CASE NO. 94-01A

Re: Zoning Commission Case No. 94-01A
(1331 L Street, NW - Request for Minor Modification to Approved
Planned Unit Development)

REVISED (7/5/06)
NCPC File No. Z.C. 94-01A

1331 L Street NW, Square 247
Washington, D.C.

REVISED PROPOSED SOUTH ELEVATION

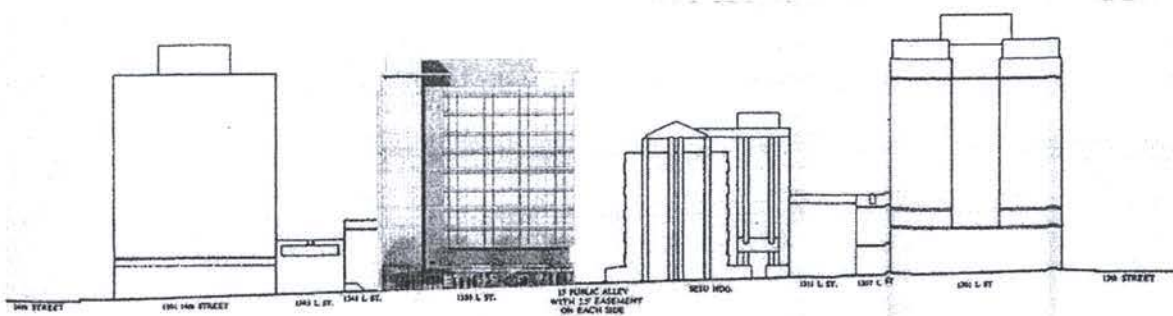
Adjacent to the tower to the east is a 12-foot wide glass reveal of a slightly contrasting accent glass that sets off the tower and marks the building entrance below. The remainder of the façade features a more horizontal expression through thin accent spandrels accented by vertical aluminum mullions. This façade along L Street is topped by an aluminum canopy element which intersects the tower, and a transparent glass guardrail to protect rooftop visitors.

While they may be permitted under District interpretation of its own Zoning Regulations, staff finds that the glass railing and canopy element are in conflict with the federal Height of Buildings Act of 1910.

Section 5 of the Height Act states that spires, towers, domes, minarets and pinnacles may be erected to a greater height than any limit prescribed in the Act. These terms all describe vertical elements that project above the roof. The canopy element is horizontal, not vertical, and is therefore not included among the elements allowed by the Height Act. It also repeats the rhythm established by the horizontal spandrels on the façade, thereby creating the visual effect of another floor.

Staff therefore recommends that the Zoning Commission exercise its discretion to require the applicant to modify the design to eliminate the canopy and guardrail, or set back these elements from the exterior walls to distances equal to their respective heights above the adjacent roof.

ILLUSTRATION OF PARAPET FROM STURGIS

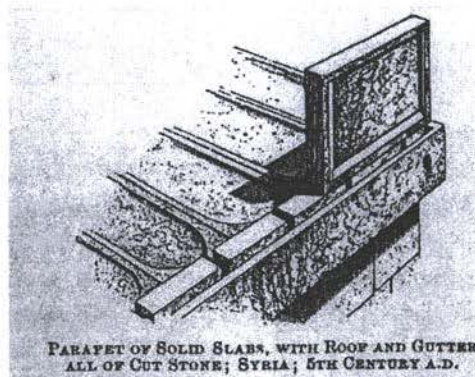
Section 7 of the Height Act states that no parapet walls shall extend above the limit of height. As defined in Sturgis' *Dictionary of Architecture and Building*, a parapet is "a dwarf wall or barrier built on the edge of a terrace, platform, bridge, balcony, or other elevated place, as a protection against falling." By this definition, the guardrail is clearly functioning as a parapet and is therefore prohibited under the Height Act. If the guardrail were set back from the edge or the roof, however, it would not meet this definition of a parapet and would be allowable.

Existing & Proposed
Penthouse Floor Plans

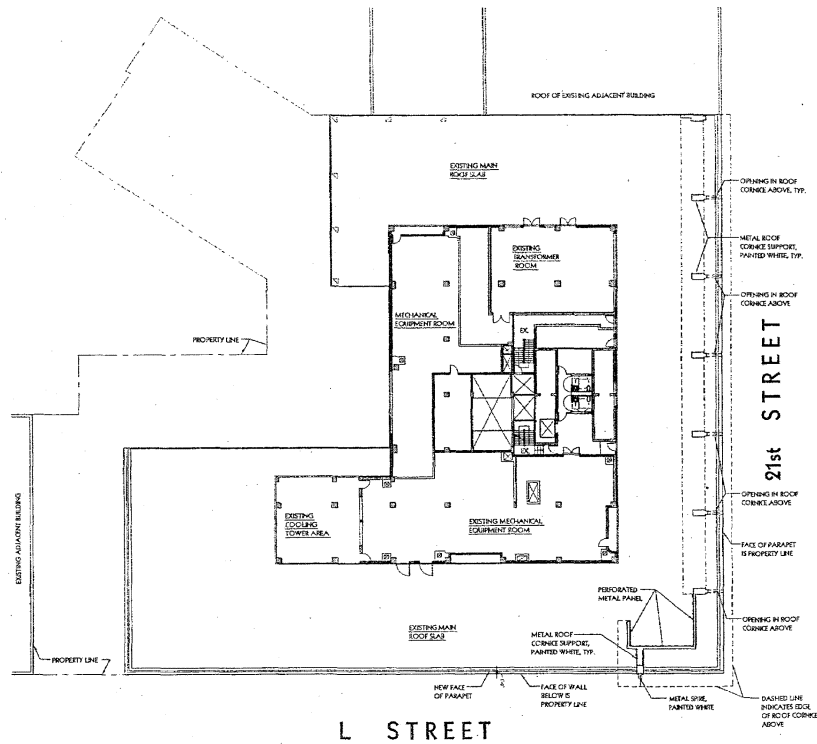
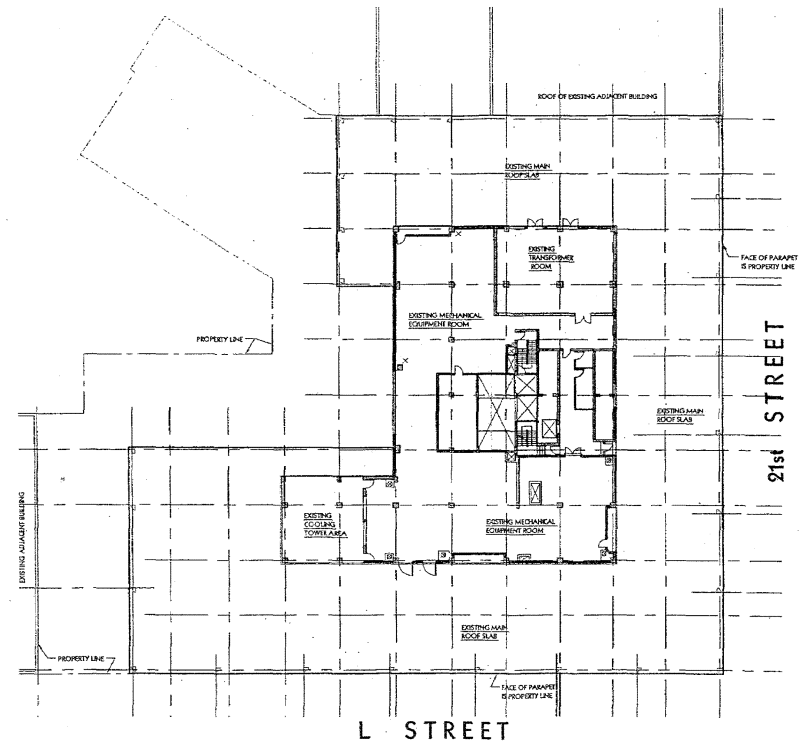
The proposed rooftop architectural ornament appears to comply with the Height Act, which requires that penthouses, ventilation shafts and tanks, but not spires, towers, domes, minarets or pinnacles, be set back from the exterior walls. Staff views the element as falling under the latter category. In its February 21, 2006 report, DCOP made no objection to the proposed design
